Oyster Creek Nuclear Generating Station
Renewed Facility Operating License No. DPR-16
NRC Docket No. 50-219

Subject: Supplemental Response to NRC Audit Review Request for Additional Information
Regarding Fukushima Lessons Learned - Flood Hazard Reevaluation Report

**Oyster Creek Nuclear Generating Station
Local Intense Precipitation Evaluation Report
Revision 8**

Figure 4: Locations of Doors

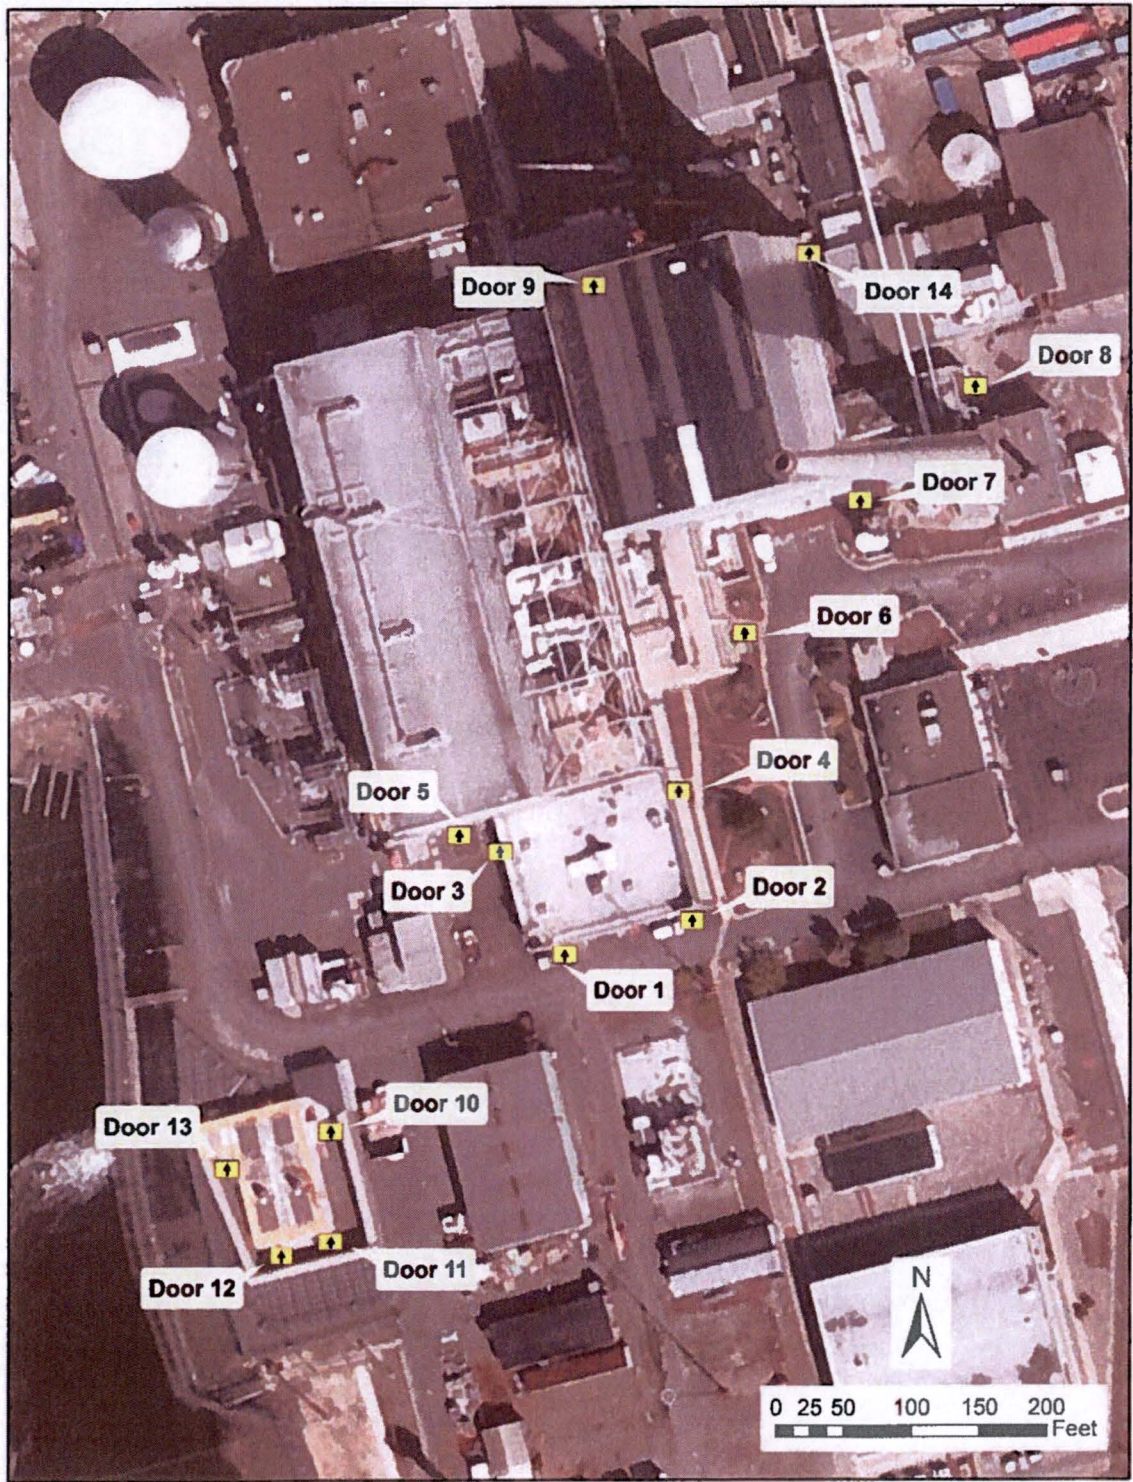
EGC's responses to the NRC clarification questions also resulted in the addition of a door previously excluded from the results summary tables in the LIP Report. Door 14 was added to Tables 4 and 5, and Figure 4 of the LIP Report (Enclosure 1), and has a threshold elevation of 23.50 ft MSL and a peak reevaluated LIP elevation of 24.38 ft MSL. Similar to Door 9, sandbags will be staged at the entrance of Door 14 as a temporary LIP barrier. The additional protection measures at Door 14 have been added as a regulatory commitment in Enclosure 3.

Item Number	Interim Actions Taken or Planned to Take as Included in the Reevaluation Report (Commitment)	Implementation Date (Committed Date or Outage)	Commitment Type One-Time Action (Yes/No)	Commitment Type Programmatic (Yes/No)
1.	Sand bags for installation at Door DR-814-39 will be pre-staged outside the Drywell processing center (South Entrance) near the Service Water Rad monitoring shed. Sandbagging Door DR-814-39 will provide protection for the RB Northeast Airlock entrance (Door 14 in Enclosure 1). There is minimal preparation and installation time required.	August 15, 2016	No	Yes
